The "Jane McCague Farmhouse"
Conservation Plan

The "Jane McCague House Driveshed"
Replication Plan

COMMENTS

Project: Jane McCague House
11121 Leslie Street
Richmond Hill, Ontario
Conservation Plan
No. 12-8b & 18-03

Figure 1 Conservation/Replication Plan Context Source: Part of Heritage House Landscape Plan prepared by the mbtw group, dated May 30, 2019.

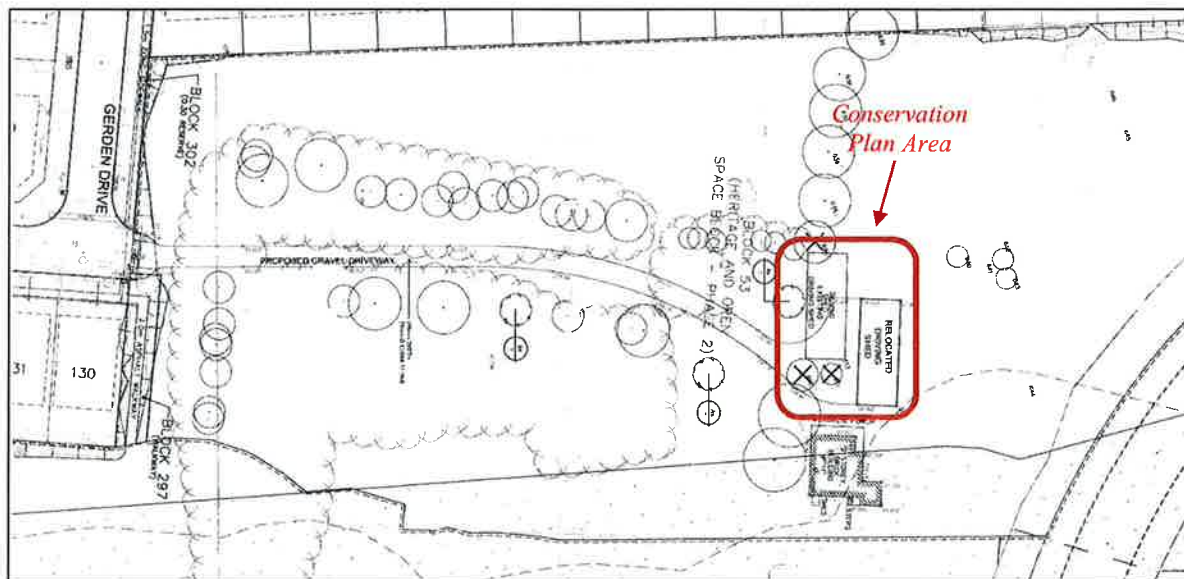
Given that the structure, including its foundation, will have to be rebuilt, the proposed relocation of the structure as shown in Figure 1 is acceptable, subject to the recommendation reorientation specified below, as it will maintain the strong visual connection between the House and the Driveshed.

Originally vehicle access to the House and Driveshed was from the west. Such access is no longer possible. The proposal, as shown in Figure 1, is to access the structures from the south. Since the recommended conservation strategy is to reconstruct the Driveshed and it is desirable for the Driveshed to be functional and useable, the reconstructed Driveshed should be reoriented, in its new location, so that the openings face the driveway (south) rather than north. As a result, on Drawing A1, I recommend that the elevations be relabeled as follows and all subsequent drawings be modified as appropriate given the reorientation:

Photograph 4

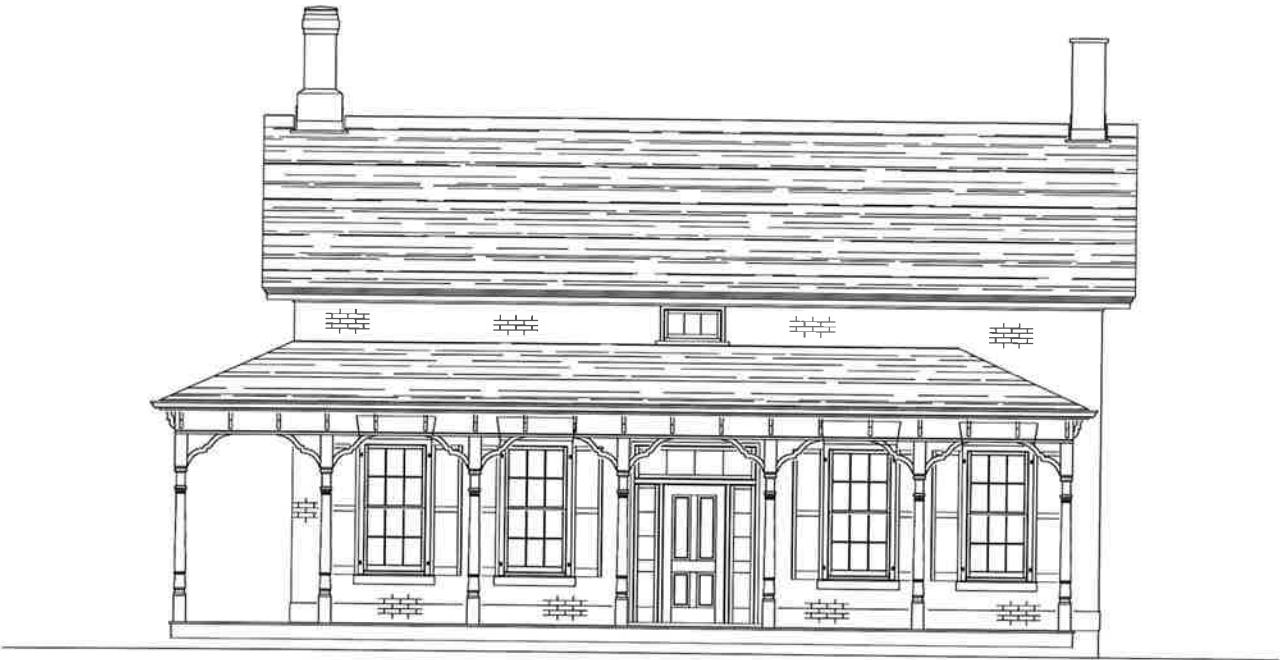
As requested by Leslie Elgin Developments Inc., Cole investigated the structural adequacy of the barn foundation located within Block 53 of the Leslie Elgin Development Phase 2 (Seen in Photograph #1). This investigation was purely visual in nature and no testing was performed. Based upon our visual observations at the site, the foundation appears to be in very poor condition, portions of the foundation are completely eroded away or missing (Seen in Photographs #2 and #3), and some portions of the walls are not sitting upon any foundation at all (Photographs #3 and #4).

It is in our opinion that the barn foundation in question is not suitable for use and should be demolished. Should the barn be rebuilt a new foundation should be constructed.

DRAWING TITLE
Exterior Elevations

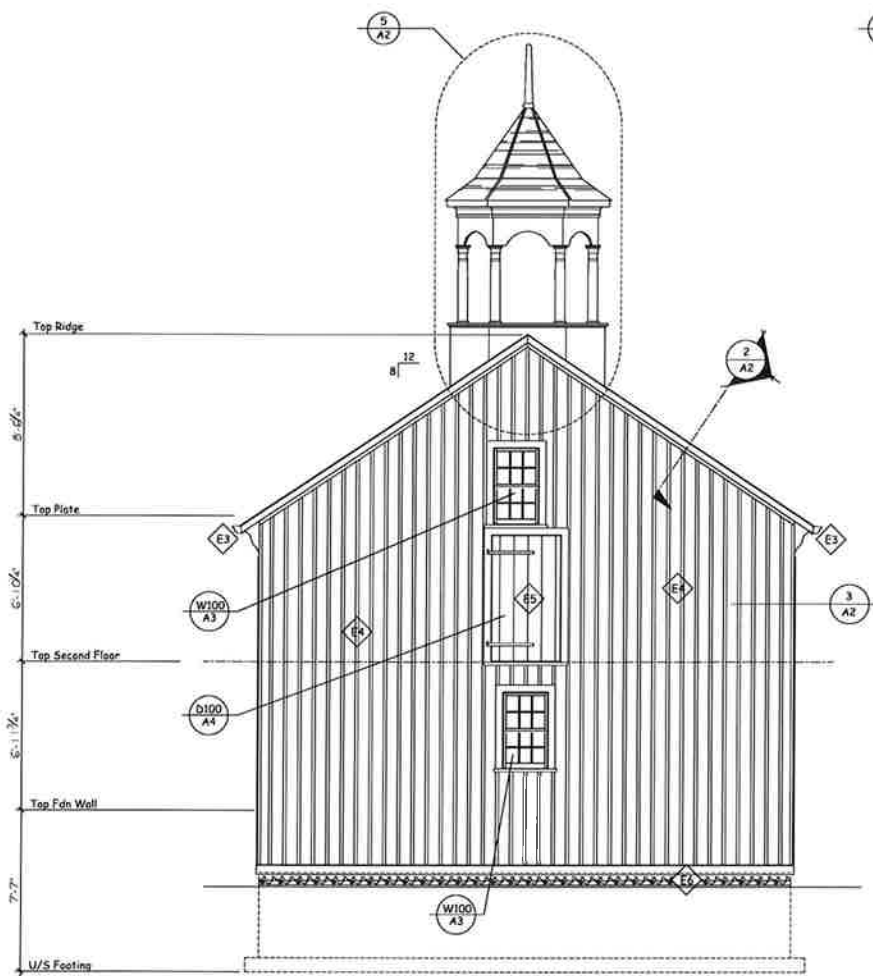
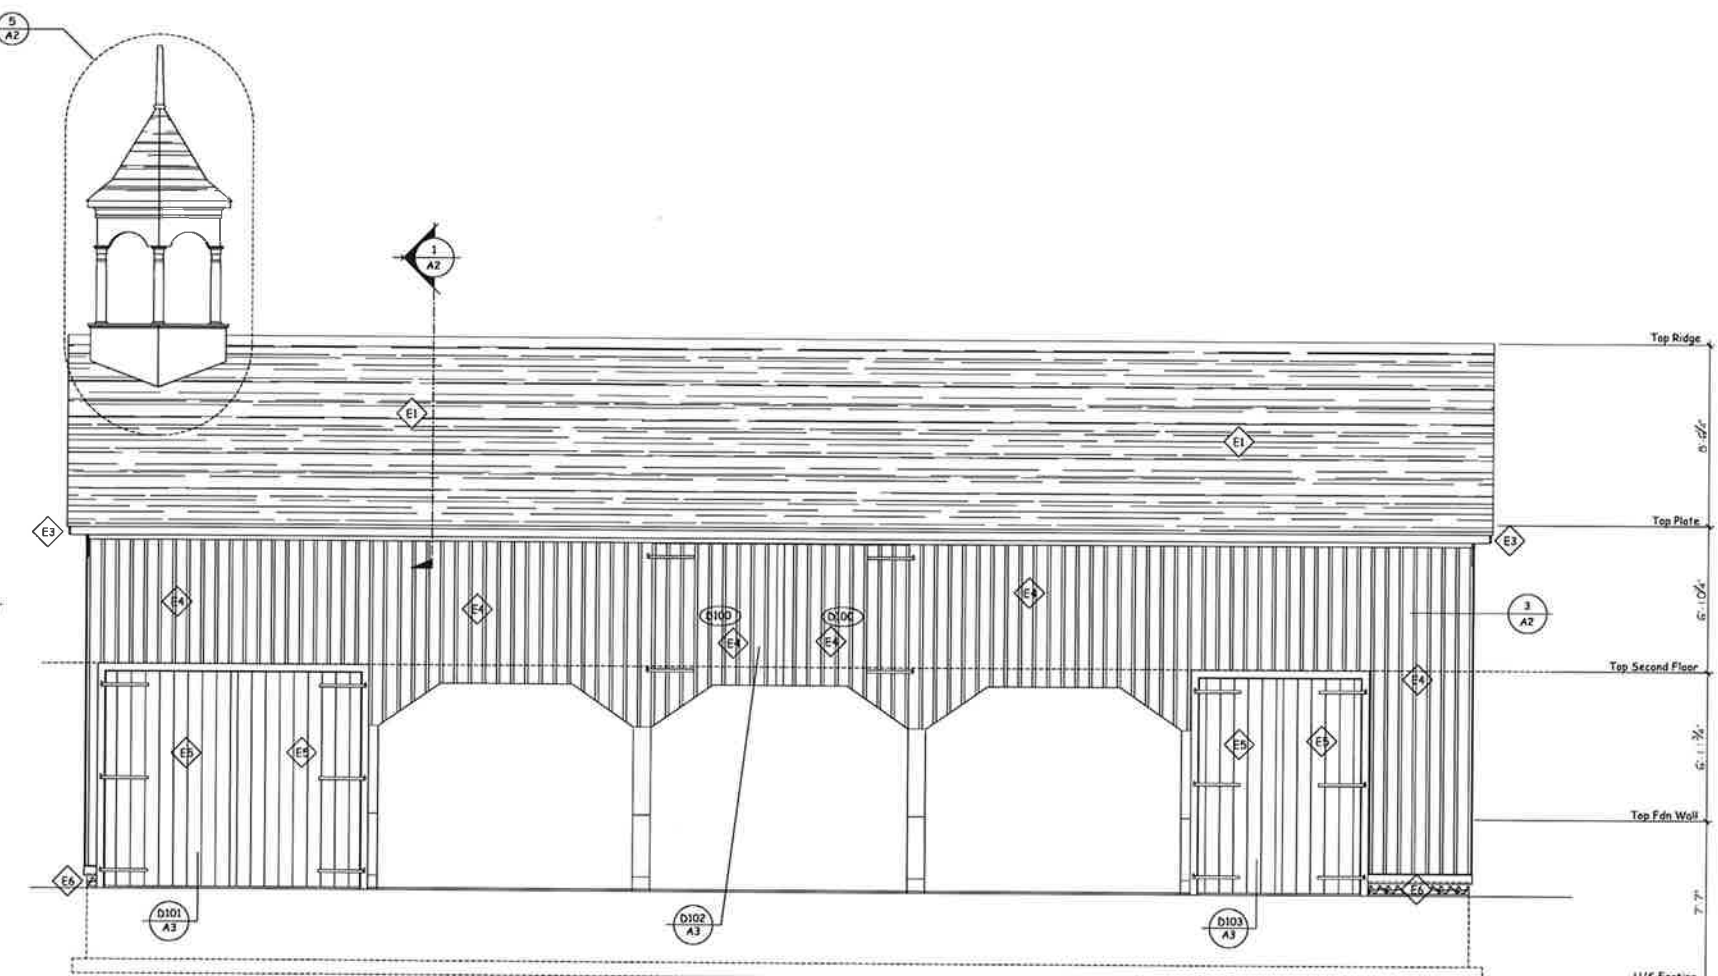
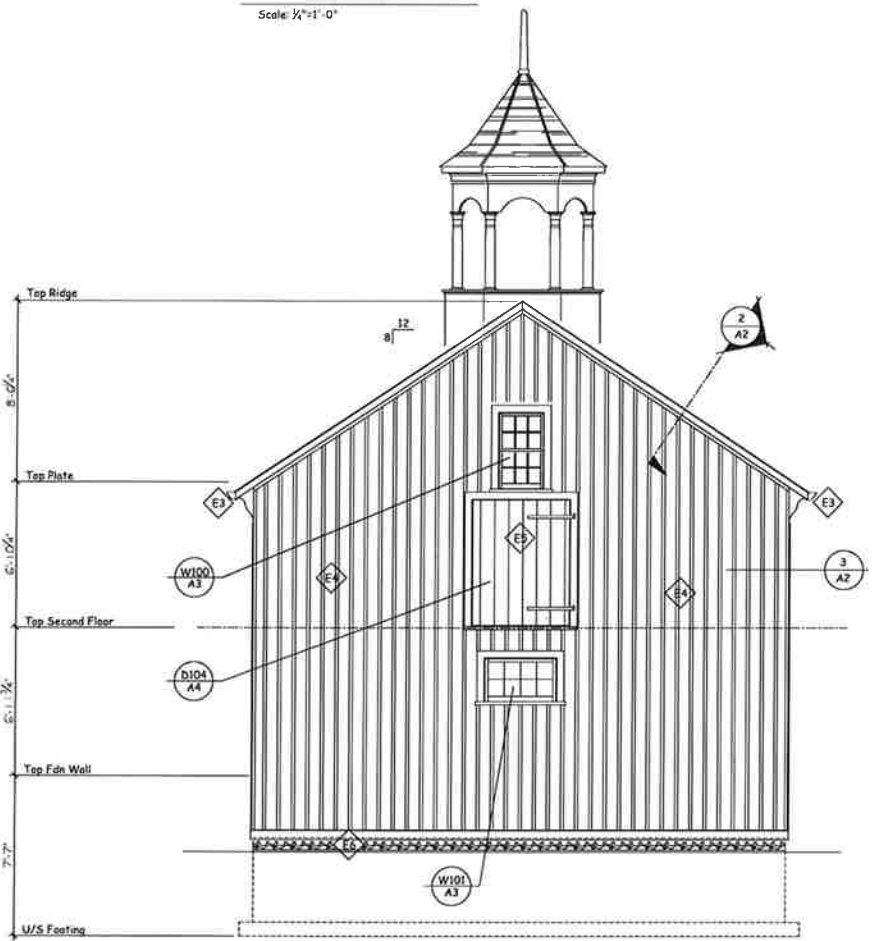
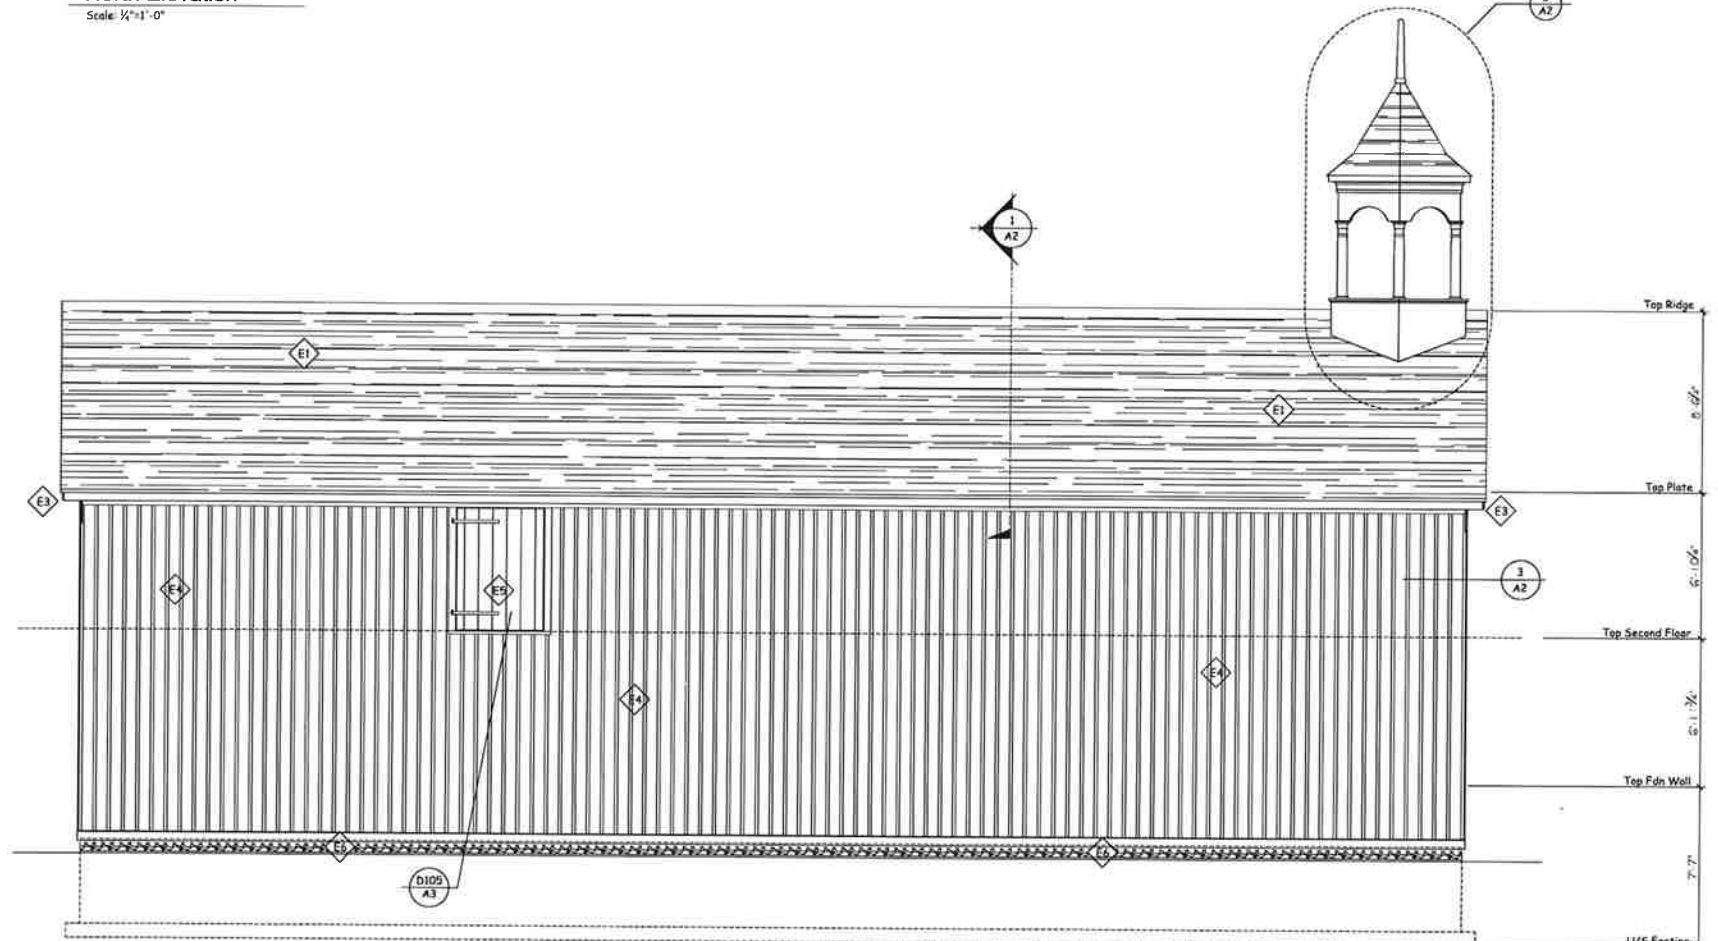
Table 1 RECOMMENDED REORIENTATION	
Drawing A1 - Existing	Drawing A1 - Recommended
North	South
South	North
East	West
West	East

1. The reorientation of the Driveshed in its new location specified in Table 1 for Drawing A1 with appropriate modifications to subsequent Drawings, and
2. The attachment of these comments to the Conservation Plan.
